SIKH GRAMMAR SCHOOL AUSTRALIA

RIVERSTONE EAST DRAFT PRECINCT PLAN EXHIBITION

Figure 2- Riverstone East Precinct- Schedule 7

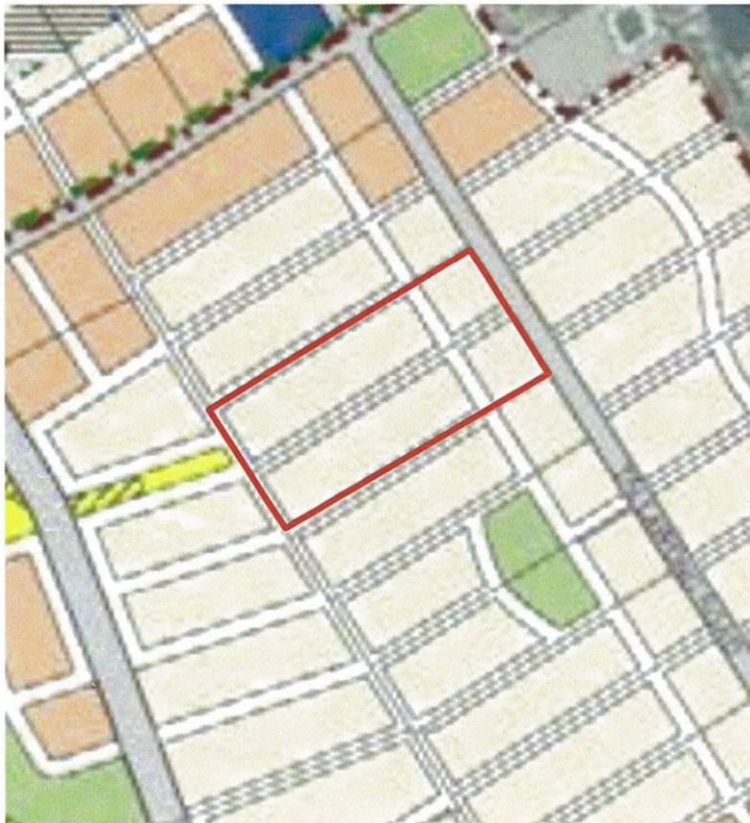
The indicative plan proposes to introduce a number of roads to the site. This will effectively divide the site into four developable blocks. We raise our legitimate safety and security concerns for the students, staff and public. Moving around different parts to access school, library, primary block, administrative block, parking and school ground, or other ancillary

buildings will create a nightmare scenario for the Students, teachers, school management, parents, local community, council, Police and transport department.

As outlined previously, the site is approved for the construction of a school and the draft ILP will not only be significantly inconsistent with the future use of the land, but also impact upon the approved plans for the site. As a result, the proposed road pattern is incompatible with the intended use of the site as a school. We raise particular concern with the north south road running parallel to Tallawong Road. We understand that it is a requirement for individual land owners to develop these roads, and as such, we would raise strong objections to the construction of all proposed roads that are internal to our site, including the north – south road running parallel to Tallawong Road and the road access from Tallawong Road to the north -south road. We note that we have no objection to the roads that are provided around the external boundaries of our property, nor do we have any objection to a road connection from Tallawong Road along our southern boundary. In fact, this road connection was pre-empted in our approved DA plans. At this early stage it is recommended that the indicative layout plan be updated to reflect the future, approved use of the land and the land use pattern that will exist.

- Remove the proposed roads through the site; and
- **E x t e n d** the road at the southern property boundary. to Tallawong Road.

We understand that the proposed layout may have been designed to accommodate rain water disposal, particularly through a natural depression that runs from the north to south. An engineering solution can be found to accommodate this without the need for a road to transect the site. The master plan for the school can include drainage pipes to ensure any water flows are accommodated across or around the site where required.
